Issue 30: Question and Multiple Question Item

Figure 33. Question Group Class Diagram

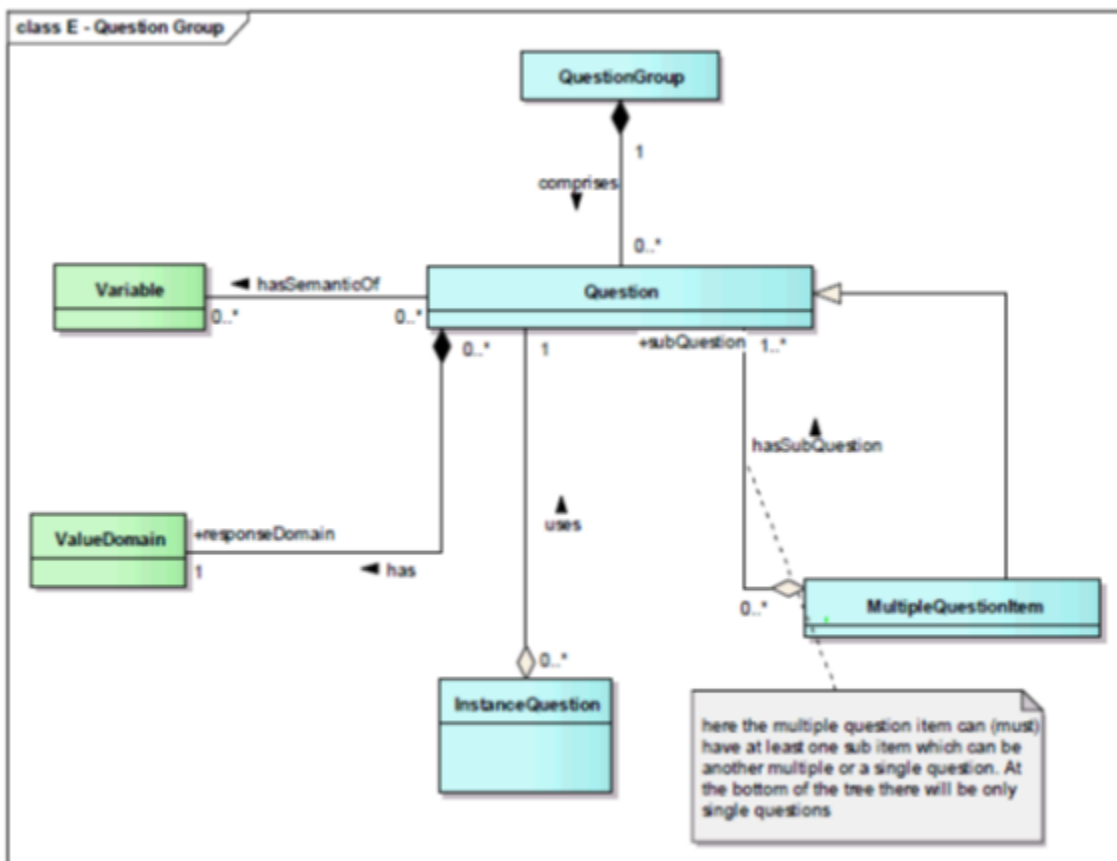
Currently the definition of question is ambiguous. The role in which it is being used in the current model is to conceptually describe a question (in an instrument), and yet it also has a subtype 'Multiple Question Item', which further defines a particular type of question, different to 'question'.

Should 'question itself be the definition of questions 'conceptually' (ie, it covers all types of questions), and then at an implementation level, the varying types can be further defined? Or are Question and Multiple Question Item significantly different enough that they warrant being two separate objects, in which case should it really be a subtype of Question?

The rule documented in Figure 33 implies it should be possible to identify what is a "single question". This might be termed a (single) "*Question Item*" which would be a more constrained 'subtype' of *Question* as an abstract.

If a *DDI3.2 Question Grid* would be considered a *Multiple Question Item* under GSIM then Figure 33 would seem to require 'sub-items' to describe (presumably) the individual 'single question' cells in the grid.

1. Remove Multiple Question Item as an object, and leave Question as a broader definition.

2. Question as abstract object, with sub-types Question Item and Multiple Question Item.

The ABS does not have any particular recommendation of solution options for the time being. For implementation in the ABS Transitional Metadata Model that is currently being developed, we have chosen to implement the second option - having both *Question Item* and *Multiple Question Item* as subtypes of the abstract *Question*.
